City of Sydney

North Rosebery Park & Green
Link

**Design Development -
Access Review v2**

8 November 2021

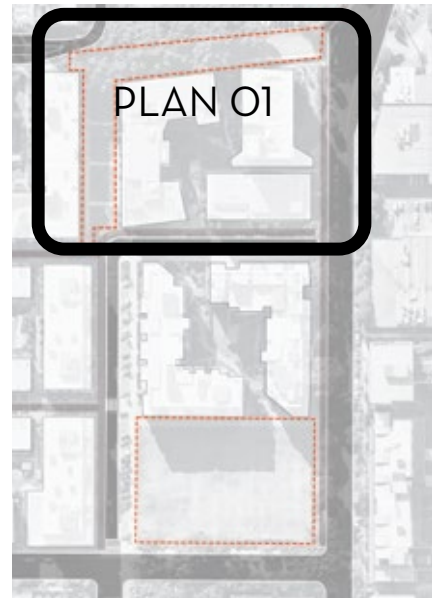
Ensure smooth transition from changes in surfaces between new and existing, or two different floor finish textures. (AS 1428.1 Clause 7).
